CITY OF HAYWARD

AGENDA REPORT

SUBJECT: **Site Plan Review Application No. PL-2005-0522 & Variance Application No. PL-2005-0488 - Hossien Mehrizi (Applicant/Owner) - Request to Build Additions to Two Residential Units and Maintain a 12-Foot-Wide Driveway for Five Units where a 20-Foot-Wide Driveway Is Required**

The Property is Located at 24073 through 24103 Silva Avenue in a RMB4 (Residential-Medium Density) Zoning District.

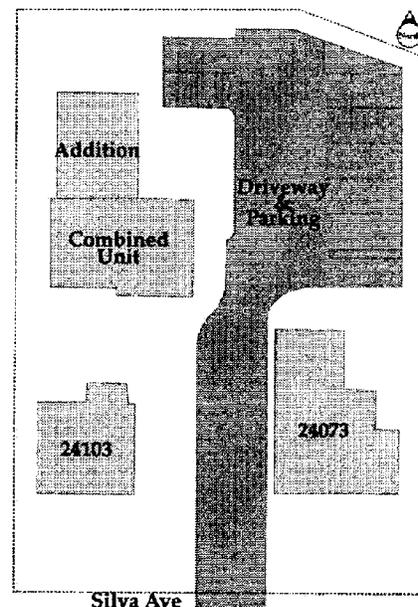
With the exception of the smallest unit at the front of the site, 24091 Silva, each building has stucco siding and aluminum frame windows. The house at 24091 Silva has original wood siding and wood-frame windows. As it appears that this house has had the least amount of improvement over the years, it may be appropriate for this to be the first house to be removed. The houses at 24073 and 24103 appear to be in the best condition. Staff would support the removal of this smallest house and the combination of the two rear units to create one large house in the rear. Only seven parking spaces would be required for the three units. Due to the reduction in the number of parking spaces, the required driveway width would be 18 feet rather than 20 feet. Staff's suggested site plan would look like the image to the right.

(A) SITE PLAN
SCALE: 1"=10'-0"

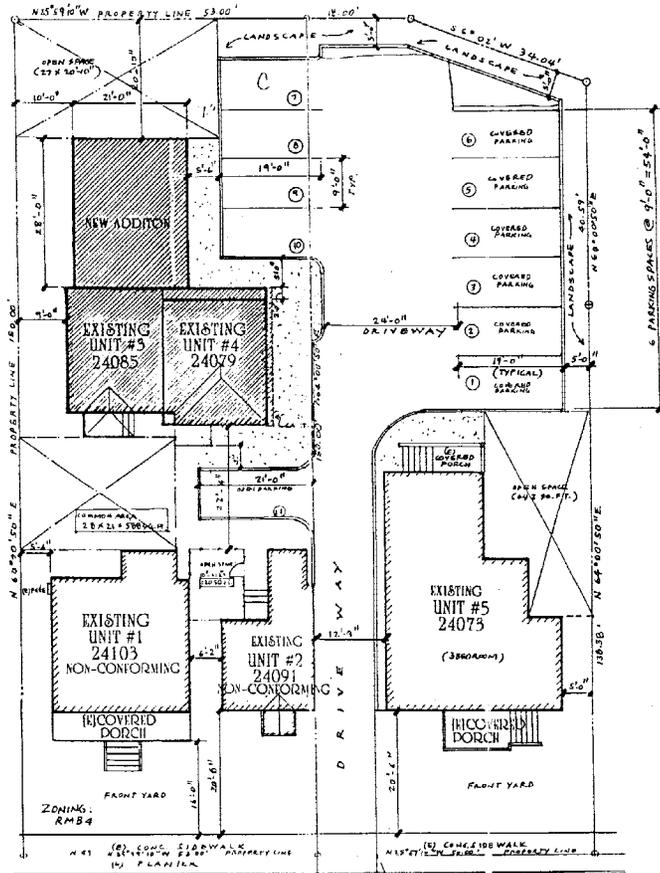
The applicant has requested to construct an addition to the two attached units (24079 and 24085). The two units would be increased from 400 square feet to 966 square feet and from 390 square feet to 1,038 square feet respectively. The five units are served by a 12-foot-wide driveway leading to a partially paved parking area at the rear of the site. There is a strip of grass on the right side of the driveway approximately 18 inches wide. On the left side the driveway directly abuts the house at 24091 Silva Avenue, which creates a constricted feeling between the buildings. There are indications that cars have hit the house on several occasions. The proposal includes formalizing the parking area by creating landscaped setbacks, new paving and striping for the required 11 spaces. The City's Off-Street Parking Regulations would require the driveway to be at least 20 feet wide with 5 feet of landscaping on each side.

As mentioned above, the zoning would allow three units if the two lots were merged, making two of the units nonconforming. Due to regulations limiting the changes that can be made to nonconforming units, the applicant proposes to designate two of the units fronting on Silva Avenue (24091 and 24103) as the two nonconforming units. No changes are proposed for these units. The designation of the two rear units as conforming units would allow for significant changes, such as the proposed addition, to be made to the units. The intent of the Zoning Ordinance, with respect to nonconforming uses, is that they eventually cease to exist. If investment is focused on the two rear units and the two front units are left as they are, then the two front units will eventually be demolished as necessary repairs become too extensive and costly. This would result in an unattractive "hole" in the street pattern. It is unknown what this space would be used for in the future. It could become an attractive nuisance as the space might be used for parking or other storage. Staff does not support any development scenario in which the front units are designated as nonconforming.

- E. The development will not be operated in a manner determined to be acceptable and compatible with surrounding development in that the five units would be served by a substandard driveway that allows only one-way traffic.

- F. There are no special circumstances applicable to the property including size, shape, topography, location, or surroundings, or other physical constraints. The property is flat and has five older rental houses that restrict the driveway width. The current Zoning allows only 3 houses. The elimination of two units would enable the property owner to widen the driveway.
